## SERVICE BULLETIN

**APPLICABILITY:** 2015-16MY Legacy and Outback Models Equipped with Navigation and Harman Kardon Power Amplifier  
**NUMBER:** 15-194-16R  
**DATE:** 02/29/16  
**SUBJECT:** Fujitsu 10/ FTEN/ F10 Navigation Voice Guidance Instructions Getting Cut Off  
**REVISED:** 04/04/16

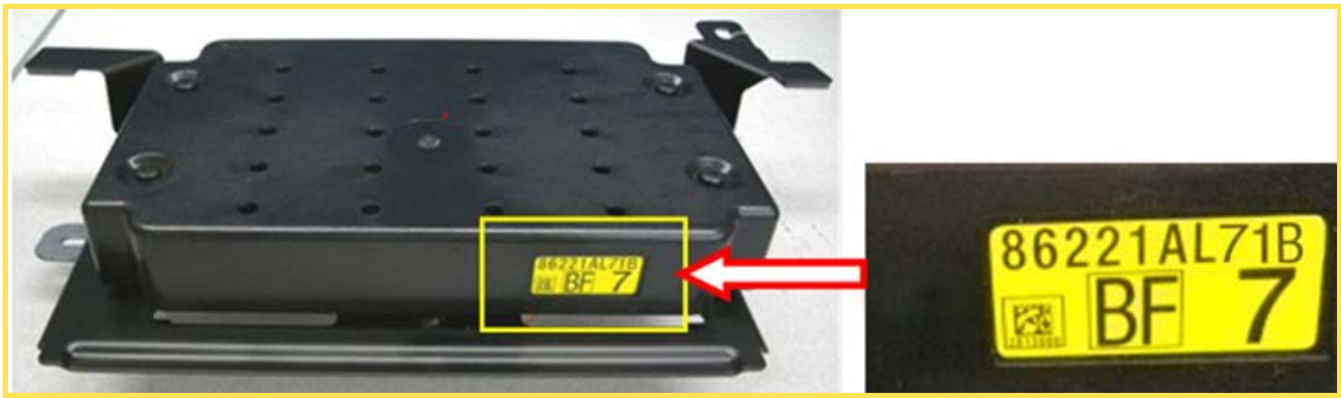
**IMPORTANT:** Power amplifiers which have part number 86221AL71B on the identification label as shown in the photo at the top of page 2, already contain this new software.

The new power amplifier part number is **86221AL71B**.
